**ATTACHMENT 6: Flood Plain Considerations for Sirius Marina**

## Flood Plain Considerations for Sirius Marina

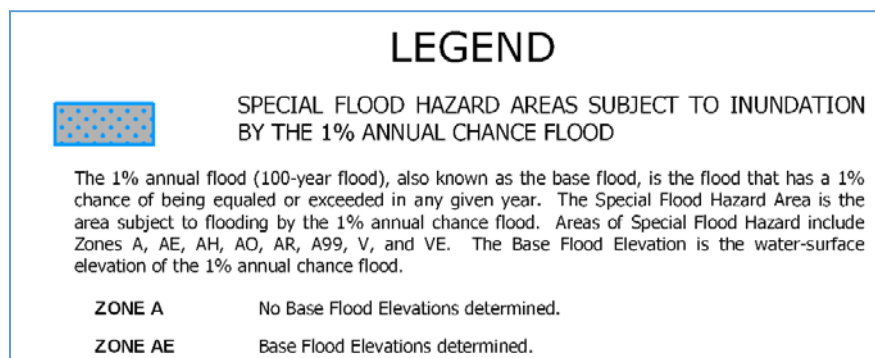
The illustration below overlays the main components of the Sirius Marina project on the FEMA flood hazard map. It is apparent that the marina upland structures (office, marina service building), the marina infrastructure (Waste Water Treatment Plant, Underground Fuel Tanks, Water Supply, Backup Generator) are all within the flood zone. It is also apparent that the proposed dredge spoil disposal site is within a flood zone and a drainage ghut traverses the site.

It is of particularly grave concern that depositing 3300 cubic yards of fine dredge spoils in a possible wetland, a known flood hazard zone, atop a mapped drainage ghut, and less than 200 feet from the shoreline of Coral Bay, is a disaster waiting to happen. A major rain event could wash tons of dredge material directly into Coral Bay harbor, smothering everything in its path. For this reason alone, the selected dredge disposal site must be denied.
